8.0 ANALYSIS OF UPPER RESERVOIR BARRIERS

8.1 OVERTOPPING ANALYSIS

FIGURE 8-7

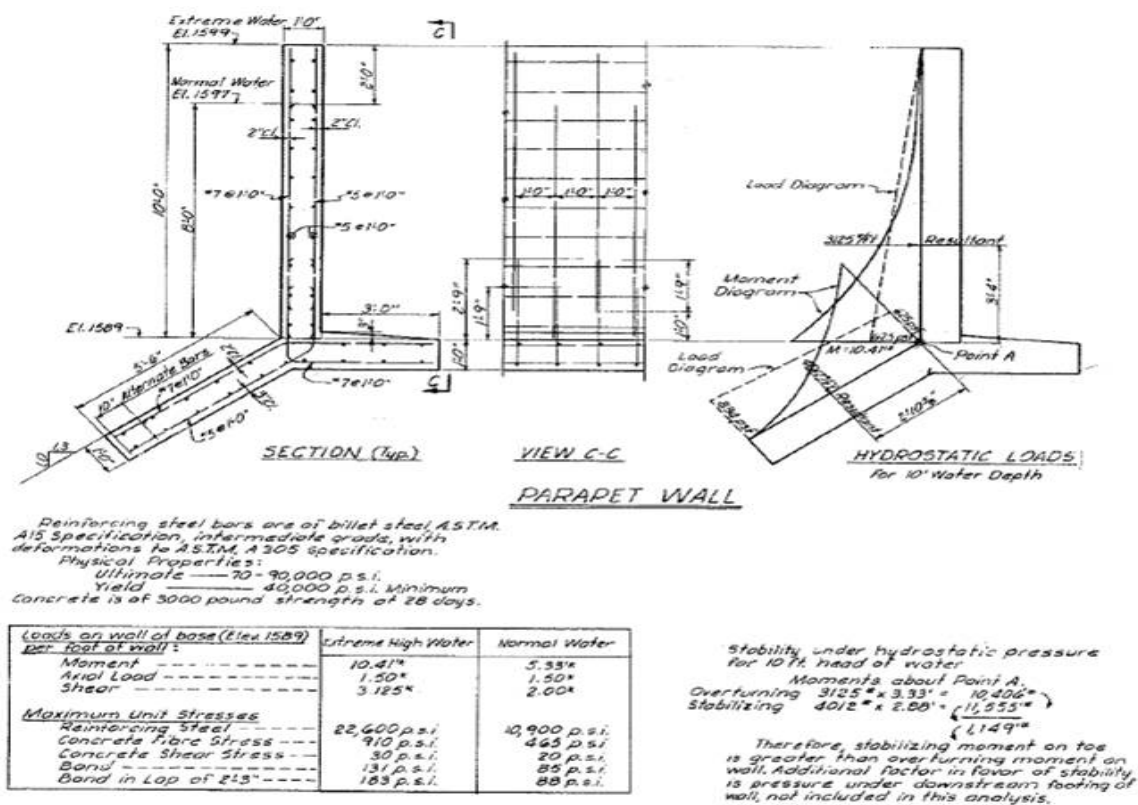
We have a few comments on this analysis. Firstly, the designer summed moments about Point A at the downstream bottom corner of the vertical stem of some of the acting forces - not all. Theoretically, one can sum moments about any point so long as all forces and moments are considered. Practitioners normally sum moments about the downstream toe, i.e., about the lower right hand corner of the base and all of the forces and moments would be considered.

Secondly, the originating analyst ignored the weight of the concrete and the soil pressure, and thirdly, the analyst ignored any uplift pressure that might develop under the foundation when the water level is in the range of El. 1598.

Our conclusion on this matter is that the original analysis would not be acceptable in a modern regulatory environment.

FIGURE 8-34

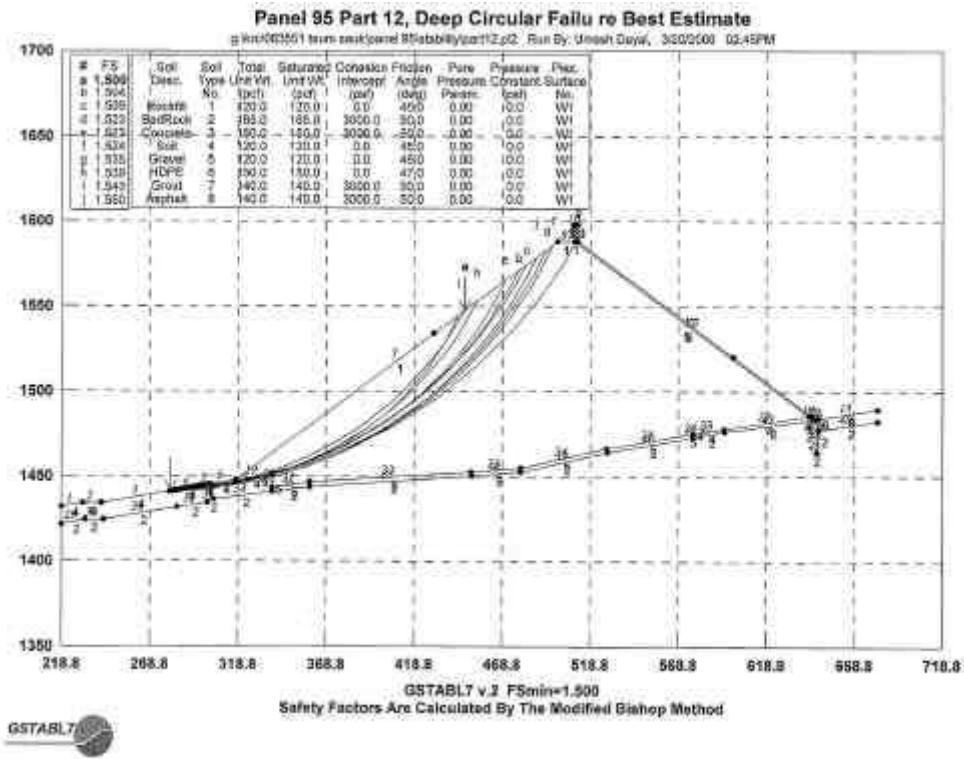
Based on our review of these analyses, RIZZO has the following comments:

Phreatic Surface: In the previous analysis, it was assumed that no pore pressure exists in the rockfill (assumed a dry slope condition). While this is often consistent with a concrete faced rockfill dam, it is not appropriate for the Dike at Taum Sauk. The high percentage of fines within a rockfill has the effect of increasing pore pressures within a dam or dike. Substantial seepage was flowing through the Taum Sauk Dike with estimates of seepage ranging from 10 to 40 cfs with an average of about 20 cfs. When this seepage flow encountered fines, increased pore pressure resulted.

Soil Properties: In the previous analysis, one type of material is assumed for the entire Rockfill Dike having shear strength properties of friction angle (ϕ) equal to 45 degrees with no cohesion. However, the original design drawings show three distinct soil layers within the downstream slope of the embankment; namely, rockfill, a filter layer, and unexcavated soil. RIZZO has performed a parametric investigation of the slope stability analyses assuming lower bound, best estimate, and upper bound material properties for each of these layers. Those material properties are listed in *Table 8-2*. The estimated material property values were back-calculated from the failed slopes and confirmed with laboratory test results. The soil and filter layers located atop the weathered rock have much lower strength values in comparison to rockfill material. This foundation layer critically governs the factor of safety for slope stability. Lower shear strength values for the foundation material yields lower factors of safety.

Wedge versus Circular Failures: The original analyses assumed uniform strength properties for the embankment and the foundation. In this case, circular failure surfaces control. However, in the case analyzed herein, the foundation layer is significantly weaker than the overlying embankment. In this case, a wedge failure (with a resulting lower factor of safety) governs the slope stability analysis.

Independent Check: As a check, RIZZO has independently performed the slope stability analyses using the same geometry and strength properties as used in the original stability calculations—not the properties that RIZZO interprets to be appropriate. The results are presented on *Figure 8-34*. These results show a factor of safety of 1.5 as reported in the original calculations prepared by the original designer.
